TO: Mercedes-Benz Dealer Principals, General Managers, Sales Managers, Service Managers, Parts Managers	FROM: Gregory Gunther, Department Manager, Vehicle Compliance and Analysis, Engineering Services
RE: Service Campaign Launch Notification Replace Tire Pressure Label MY20-21 167(GLE-Class, GLS-Class)	Date: November 13, 2020

Campaign No. 2020110009, November 2020

SUBJECT: **Model GLE-Class and GLS-Class vehicles (167 and X167 platform)**
Model Year 2020-2021

Replace Tire Pressure Labels

Figure 2

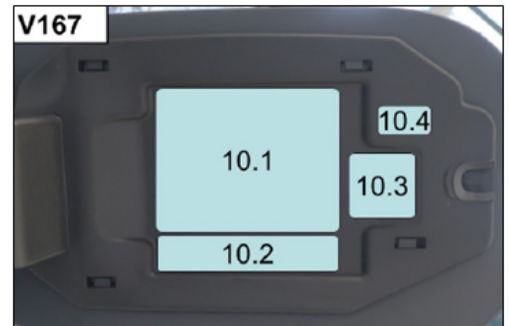
1. Replace tire pressure information label (**figure 1**) on inside of fuel filler flap (**bonding position 10.1, figure 2 or 3**).

i Remove tire pressure information label on inside of fuel filler flap, remove any residual adhesive, and clean bonding surface.

i The tire pressure information label must be determined in accordance with the equipment code for the vehicle identification number via the parts process in the XENTRY Portal!

Figure 4

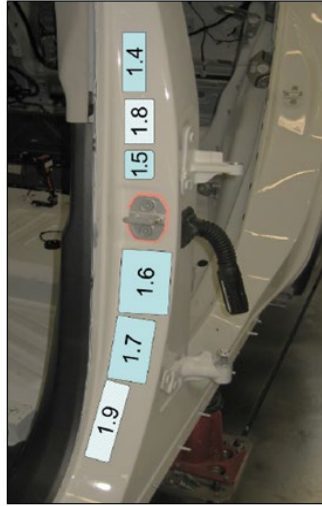
2. Replace additional tire pressure label (**figure 4**) at left B-pillar (**bonding position 1.7, figure 5**).

i Remove additional tire pressure label at left B-pillar, remove any residual adhesive, and clean bonding surface.

i The additional tire pressure label must be determined in accordance with the equipment code for the vehicle identification number via the parts process in the XENTRY Portal!
